Circuit Revision Change to the XC9500XL Family of CPLD Devices

PCN2004-25 (v1.1) January 24, 2005

Product/Process Change Notice - FYI

Design Circuit
Revision Code

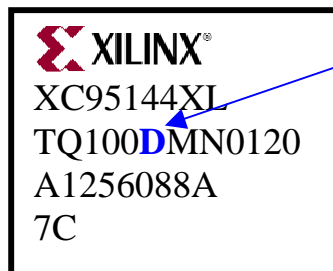
As part of the Xilinx continuous improvement process, a new circuit revision is being released for each member of the XC9500XL family of CPLD devices. This new circuit revision increases the tolerance of the configuration circuitry to non-monotonic power supply ramps and provides a more robust solution in customer applications. This revision is backward compatible to the revision C material that is currently shipping in production. The new circuit revision can be identified by design circuit revision code D (see *Traceability* below).

The design circuit revision code on the package topmark can be found as shown below.
